Possible Environmental Impacts of the Plaquemines LNG Project to Marine Mammals in the Gulf of Mexico

Aaron N. Rice, Ph.D.

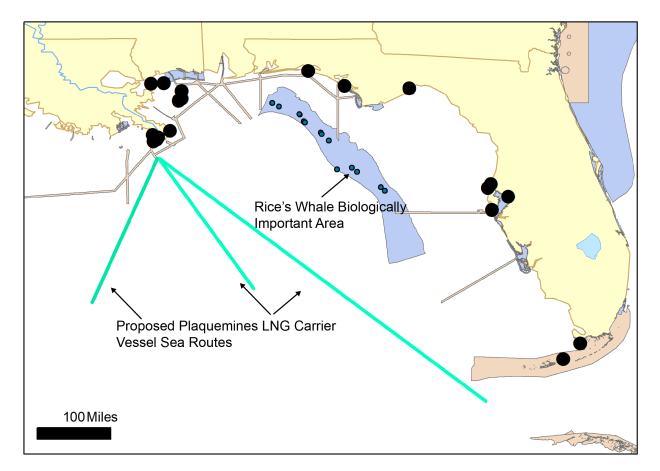
In the Plaquemines LNG EIS, Figure 2.1-3 shows the LNG Carrier Sea Routes for vessels leaving the LNG terminal in Louisiana. The sea route extending to the southeast gets within 65-100 km to the Rice's whale Biologically Important Area (Figure 1). While vessels may not physically pass through the area, noise from transiting ships would propagate across the Rice's whale core area. The NOAA Nautical charts used to generate Fig. 2.1-3 were last updated in 2013 (https://charts.noaa.gov/OnLineViewer/411.shtml), which preceded the identification of the Biologically Important Area for the Rice's whale (LaBrecque et al. 2015).

In their identification of Rice's whale stranding events, Rosel et al. (2021) identify five stranding events of Rice's whales/Bryde's whales or "Bryde's-like whales" near the Plaquemines LNG

terminal site (Figure 1), suggesting that Rice's whales may venture closer to shore and outside of their core area putting them at risk of both elevated noise exposure and ship strikes (Soldevilla et al. 2017).
